GEC INDEX SHEET

UNTIL SUCH TIME AS THESE DRAWINGS ARE APPROVED BY THE APPROPRIATE REVIEWING AGENCIES, JR ENGINEERING APPROVES THEIR USE DESIGNATED BY WRITTEN AUTHORIZATION.	PREPARED FOR	SR LAND, LLC 20 BOULDER CRESCENT 2ND FLOOR COLORADO SPRINGS, CO 80903 JAMES F. MORLEY (719) 419-3024
	DESIGNED BY	JR ENGINEERING A Westman Company Central 303-740-9888 • Colorado Springs 719-583-2583 Fort Collins 970-491-9888 • www.jrengineering.com
BY	DATE	
No.	REVISION	
H-SCALE	1"=400'	N/A
V-SCALE		
DATE	7/18/23	DJV
DESIGNED BY		WLL
DRAWN BY		
CHECKED BY		
SAND CREEK RESTORATION	GEC PLANS	
SHEET 96	OF 121	
JOB NO.	25188.04

SAND CREEK RESTORATION	GEC INITIAL	BY	DATE	No.	REVISION
		H-SCALE	1"=60'		
		V-SCALE	N/A		
		DATE	7/18/23		
		DESIGNED BY	DJV		
		DRAWN BY	WLL		
		CHECKED BY			
		SHEET	97	OF	121
		JOB NO.	25188.04

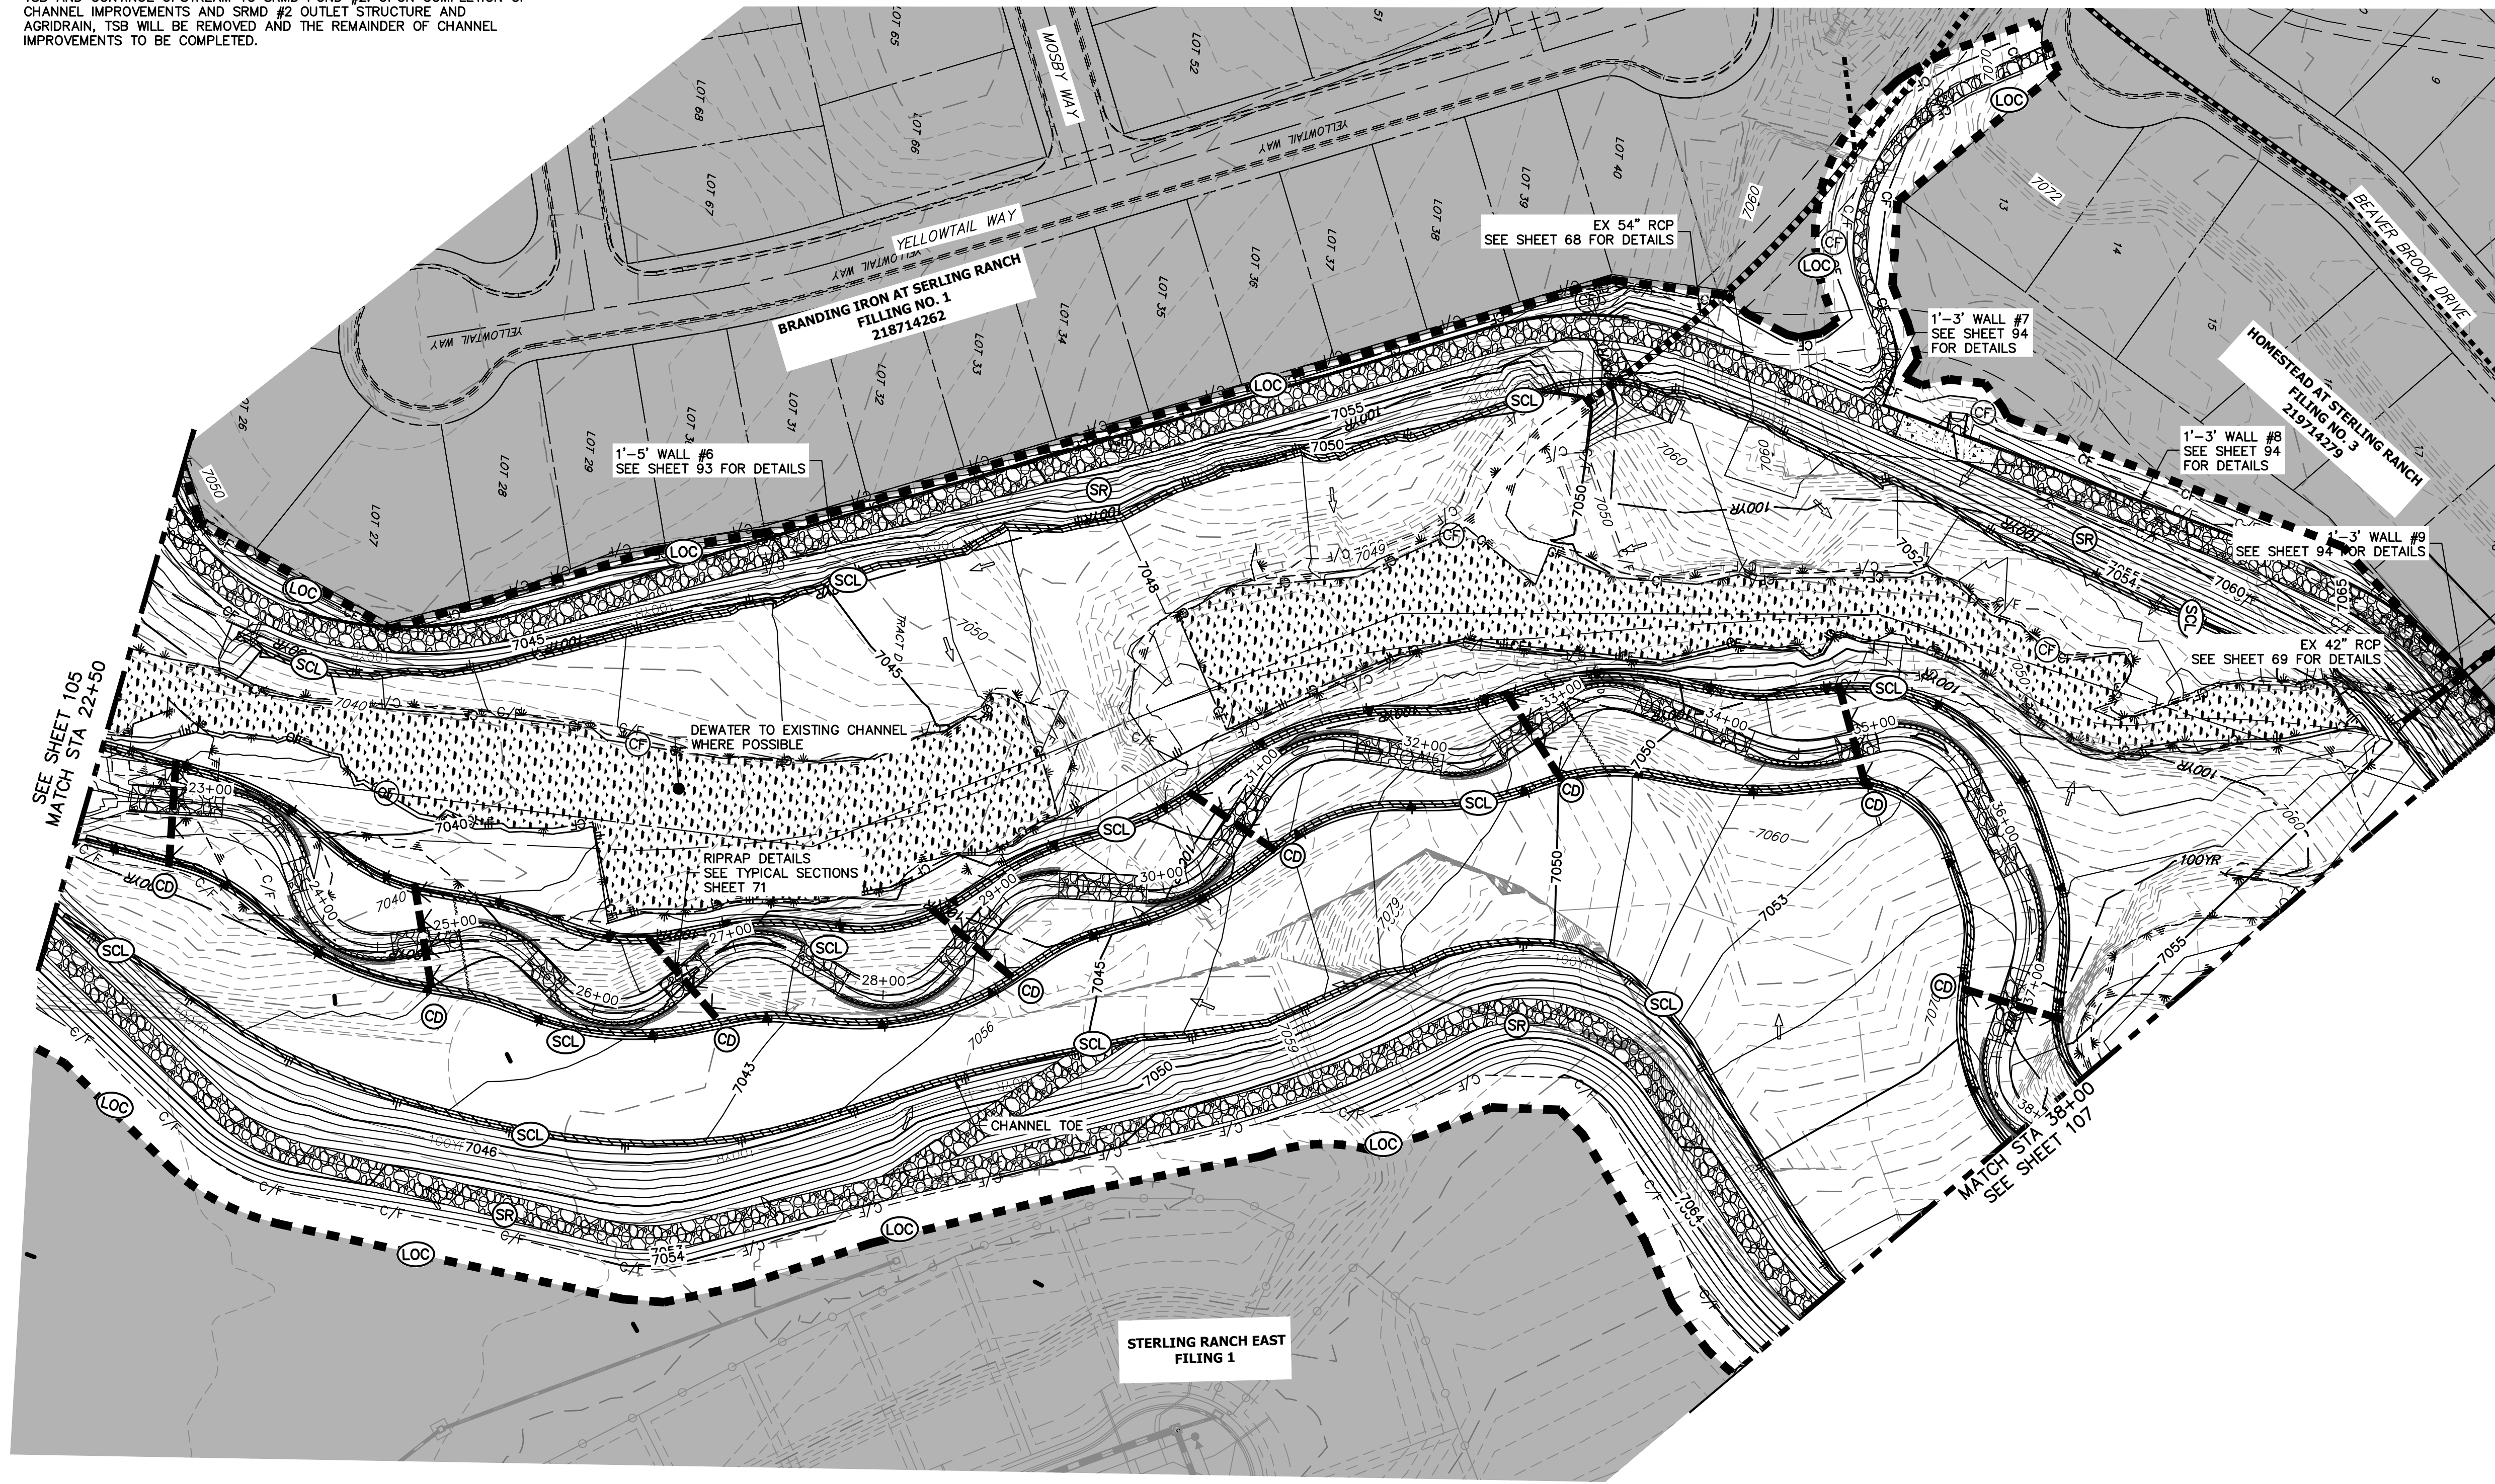
Reference the plan set for interim (prior) grading

SAND CREEK RESTORATION	GEC INTERIM	DESIGNED BY	DJV
		DRAWN BY	WLL
SHEET 106 OF 121		CHECKED BY	
JOB NO. 25188.04

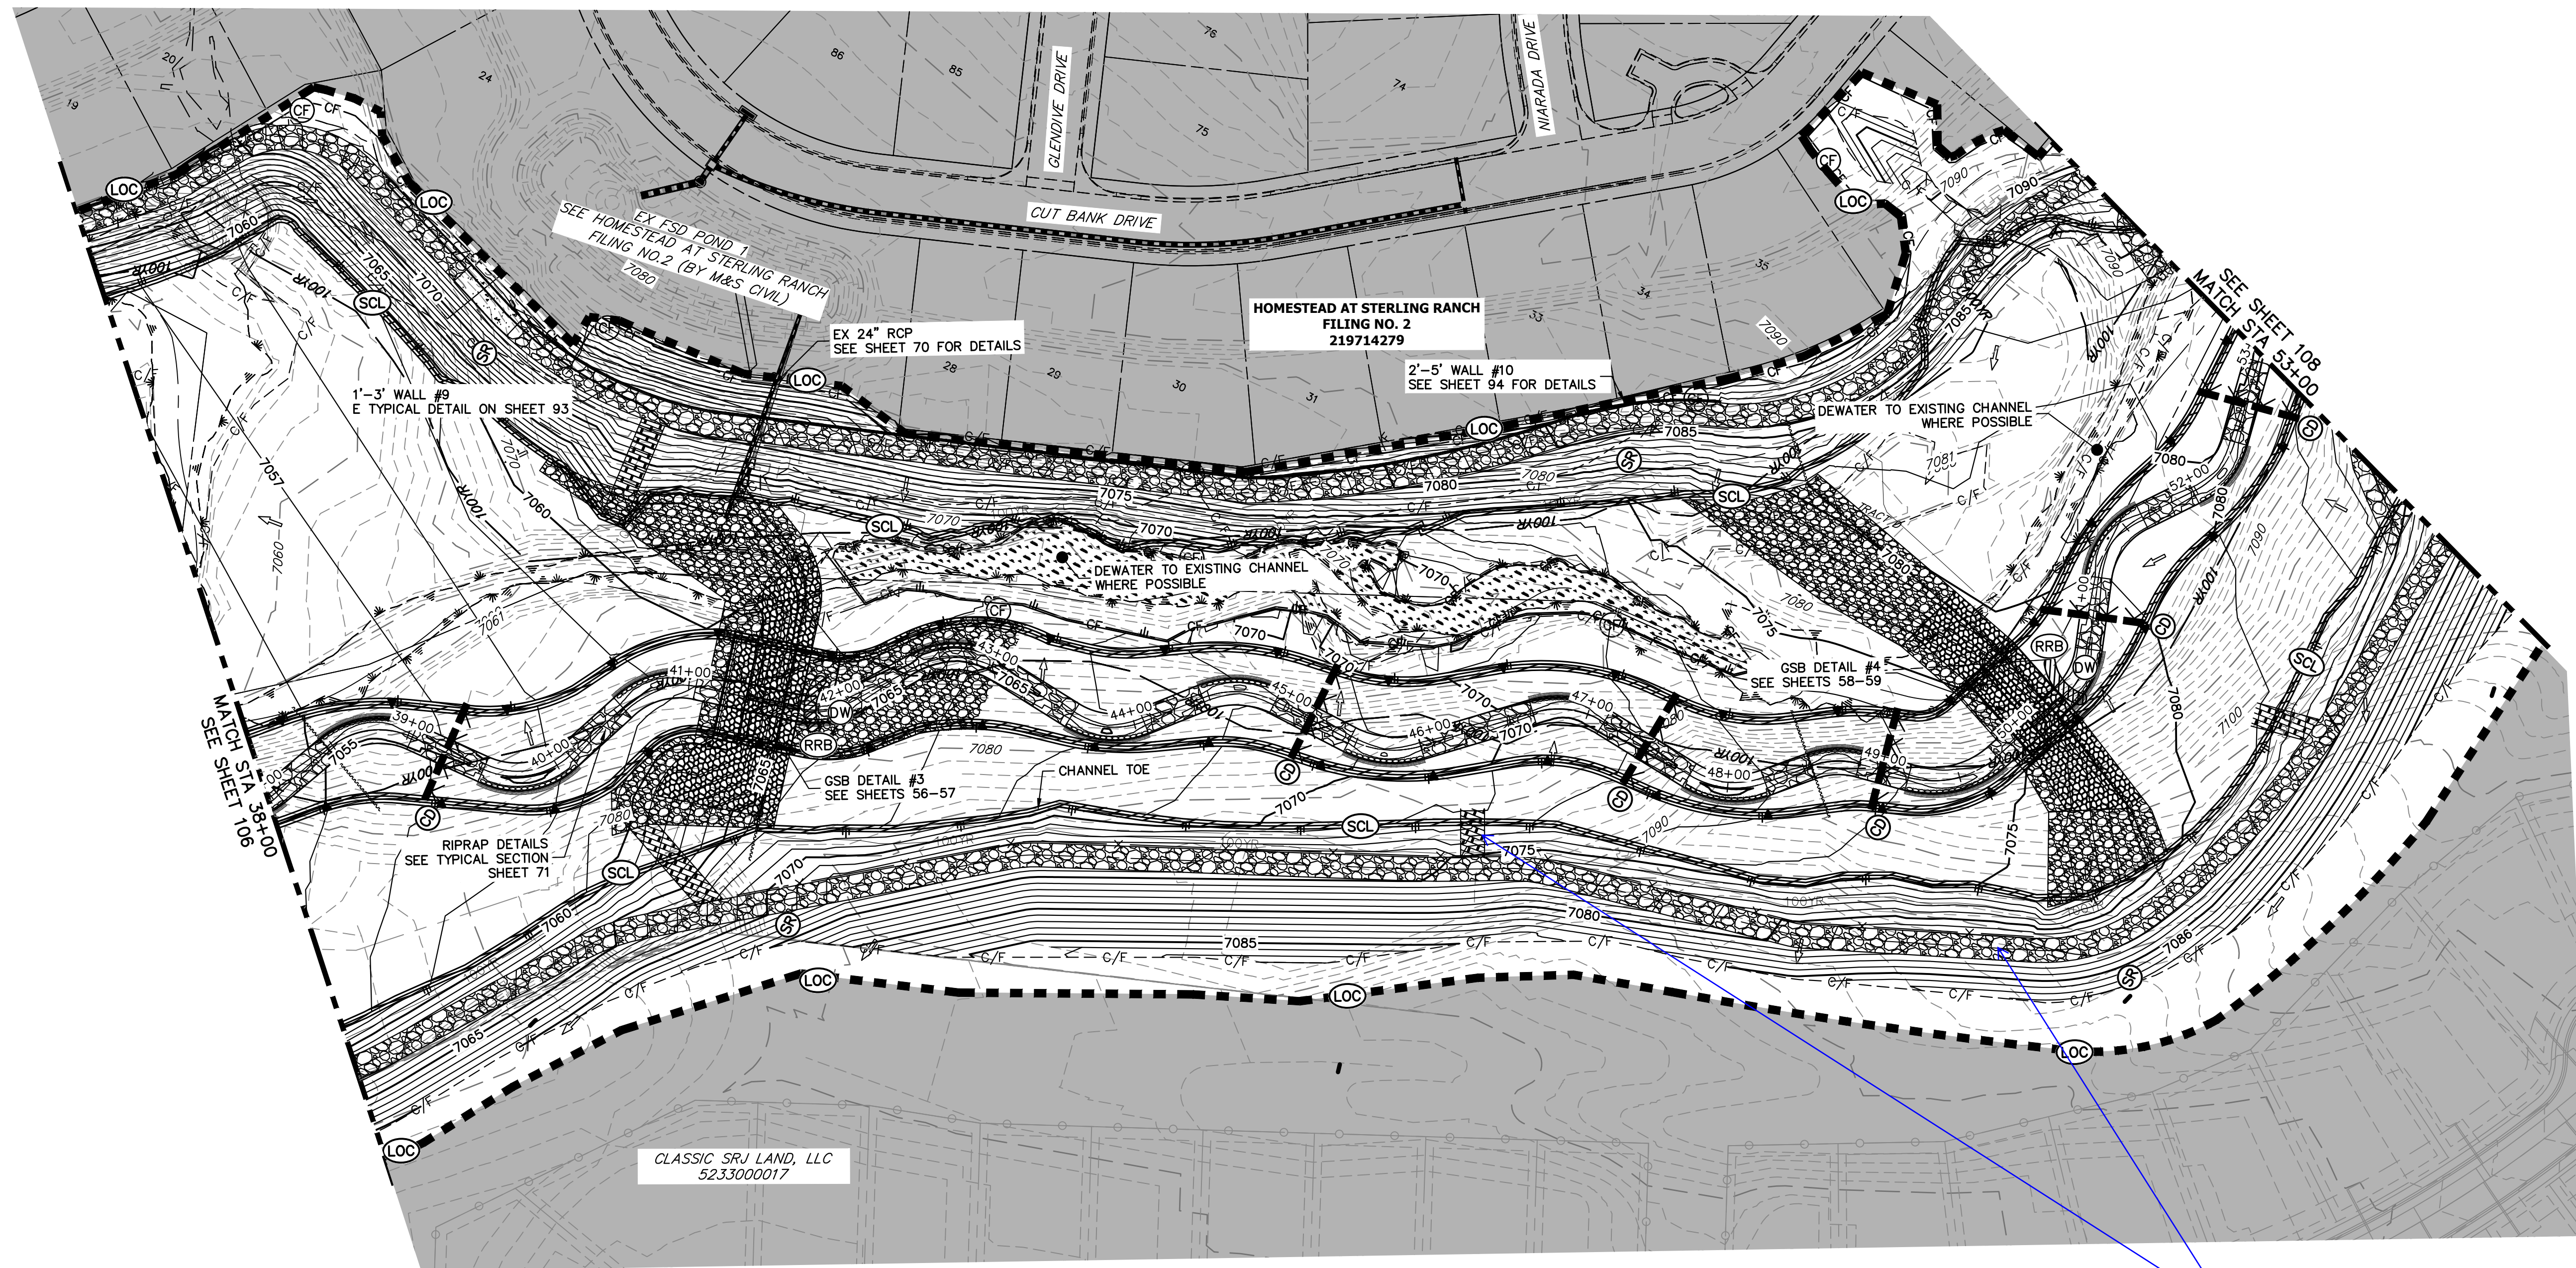
Unresolved: Add hatching to legend or label
